Development Review Committee Meeting

1. Development Review Permit for the construction of a ±4,300 square foot retail paint store for Sherwin-Williams on a ± 1.5 acre parcel (after pending lot line adjustment) on Nevada City Highway (next to Lumberjacks Restaurant)

Prepared by: Amy Wolfson, City Planner

Application Number: 23PLN-41
Subject: Development Review Permit for the construction of a ±4,300 square foot retail paint store for Sherwin-Williams on a ± 1.5 acre parcel (after pending lot line adjustment) on Nevada City Highway (next to Lumberjacks Restaurant)
Owner: Matt McWhirter (representative)
Applicant: McWhirter Realty Partners
Zoning/General Plan: Central Business (C-2) Zone/Commercial
Entitlements: Development Review Permit

4 EAST ELEVATION
 1/8" = 1'-0"

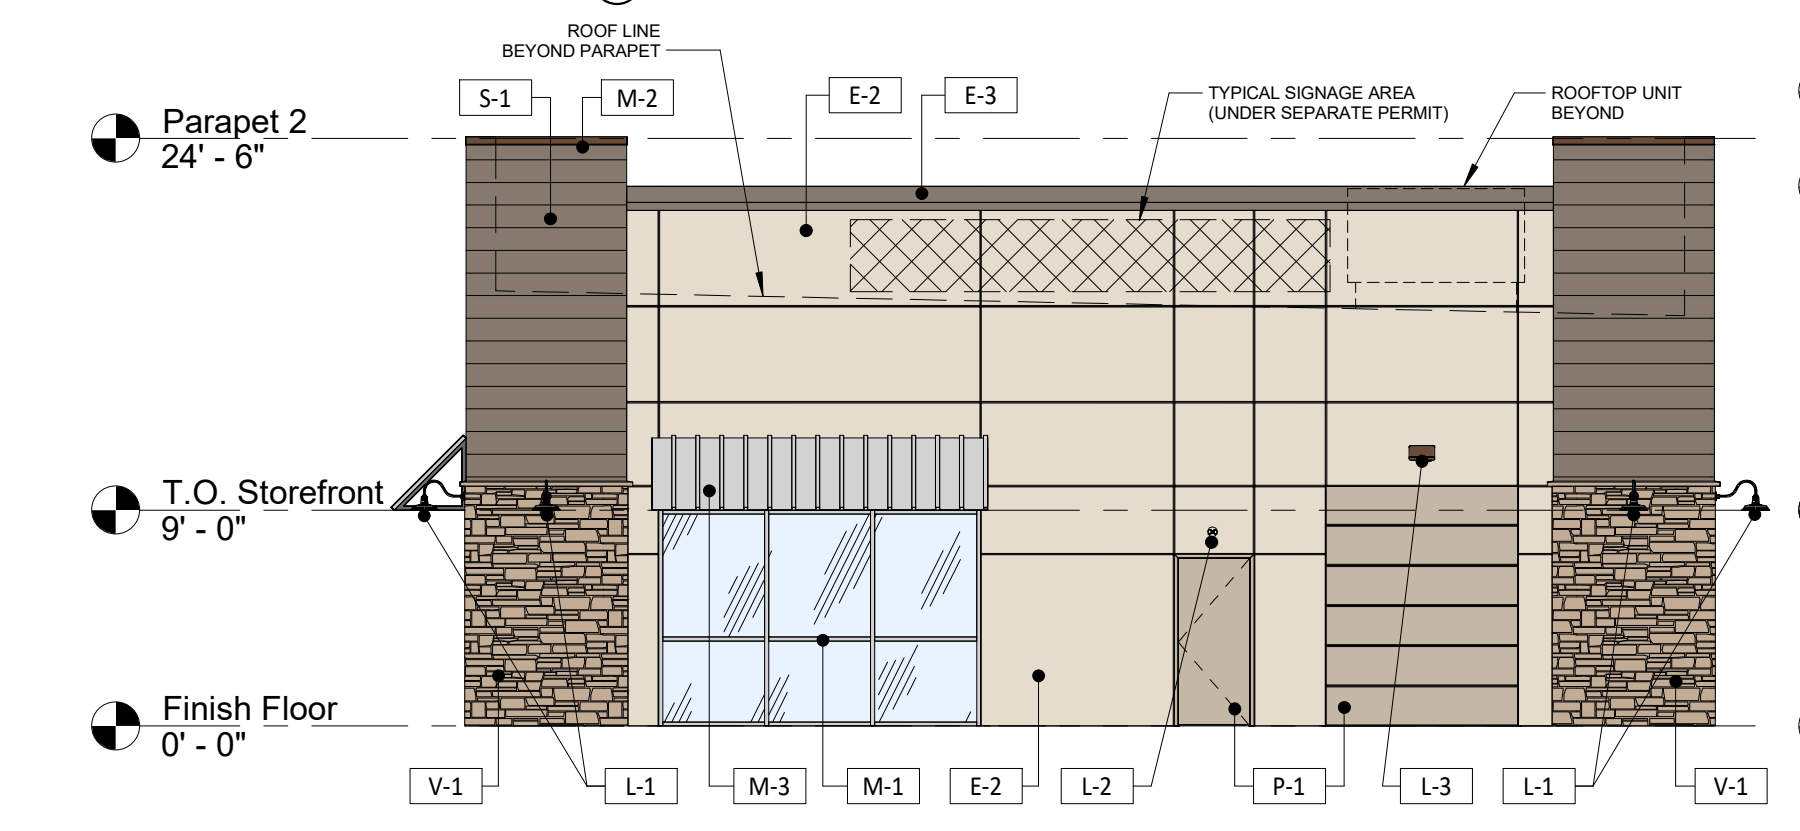
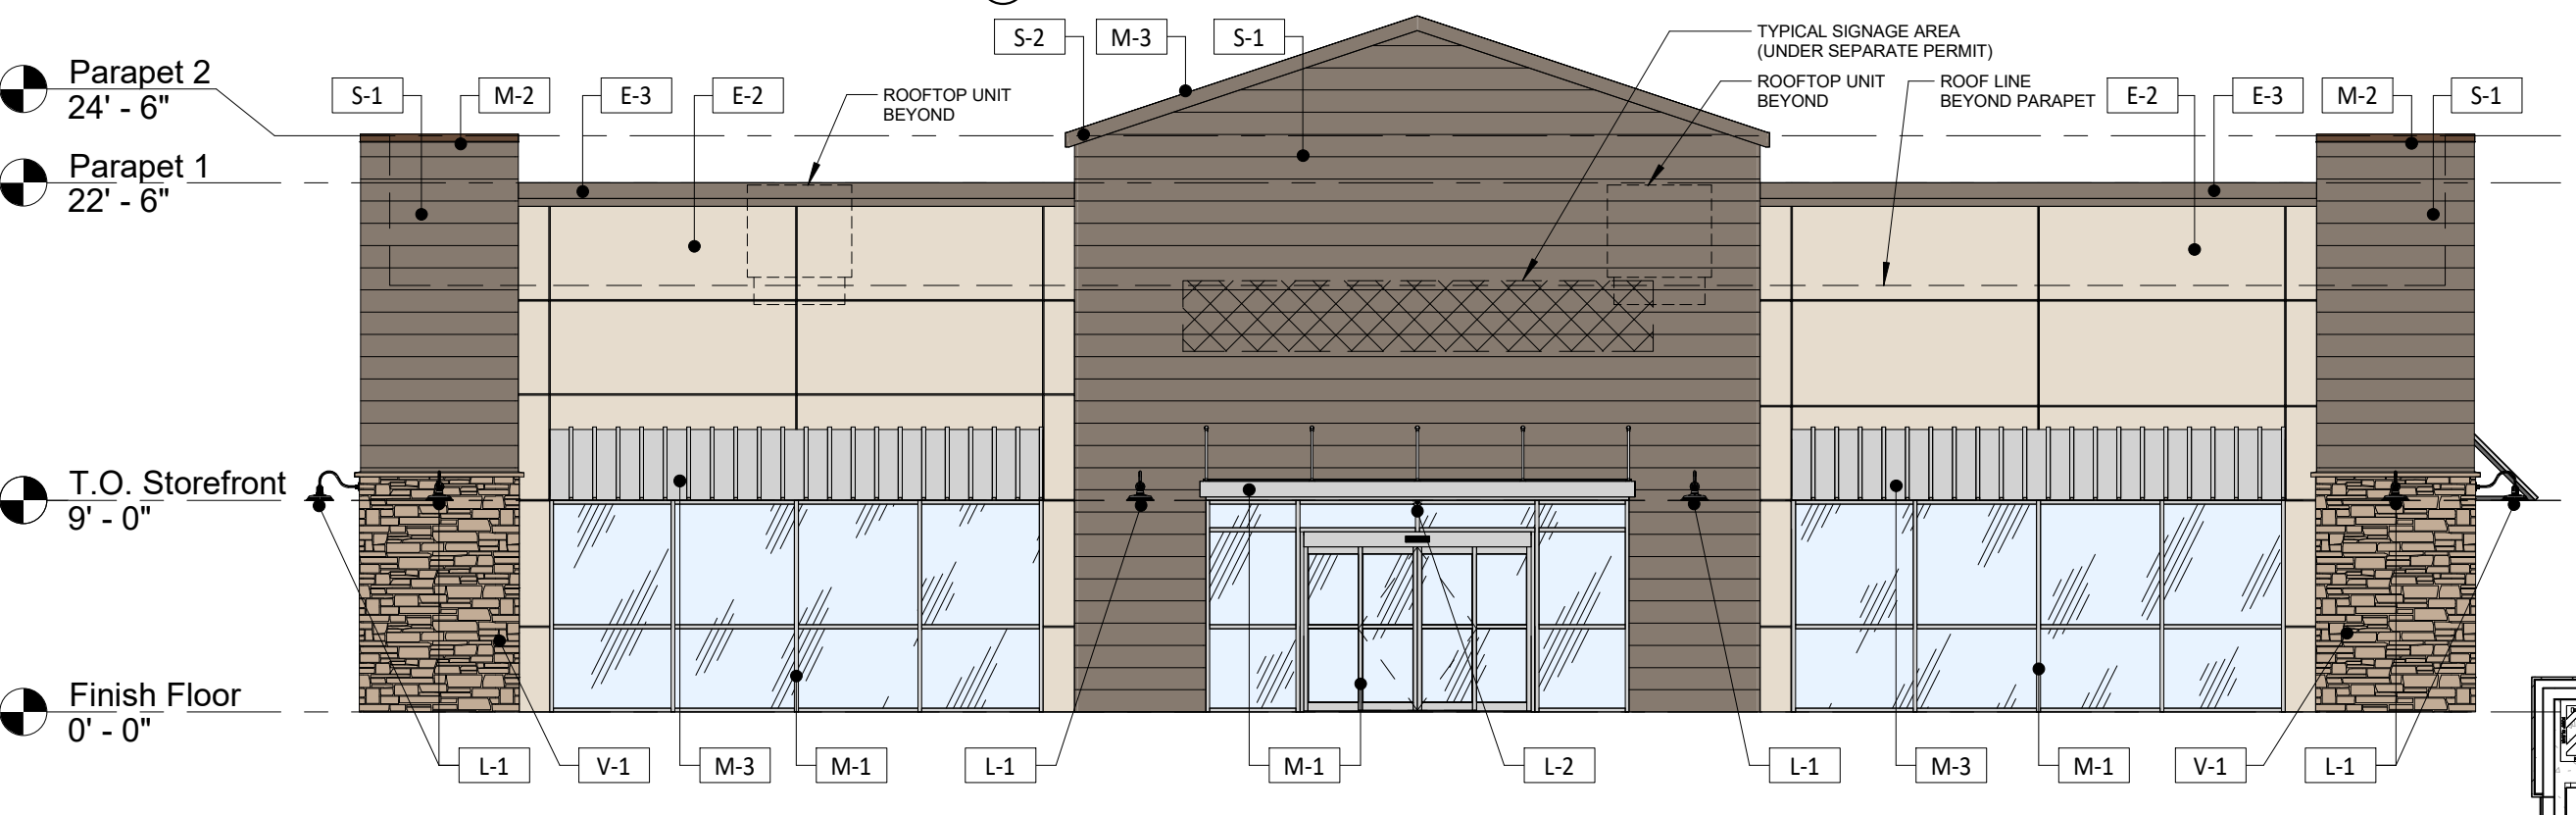
10. The applicant shall file for a sign permit prior to erecting signage.
11. The security lighting labeled on the light schedule as "L-2," and referenced on the east and south elevations will need to be revised to comply with the city's outdoor lighting standards in section 17.30.060 of the city municipal code.
